WIVENHOE DAM

ANNUAL DAM SAFETY INSPECTION 2008

EXECUTIVE SUMMARY

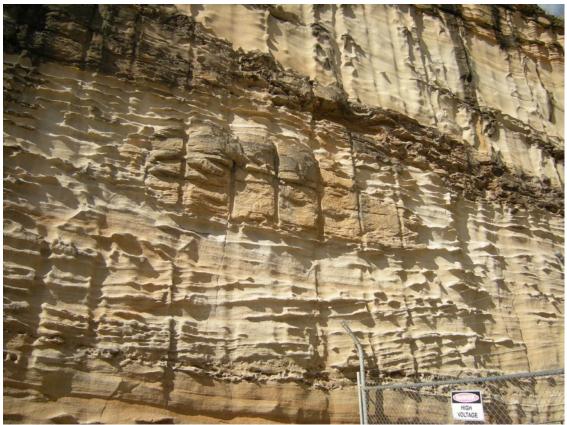
The mechanical equipment in the outlet works was inspected and found to be in generally good condition. Internal inspection of the conduits and valves had occurred within the last five years and will occur again at or before the next five year comprehensive inspection. Issues were identified that relate to water leaking into the outlet works area through the service penetrations to the mini-hydro facility and these water leaks should be repaired.

• Seal the service penetrations to the mini-hydro facility as these are causing water leaks into the outlet works.
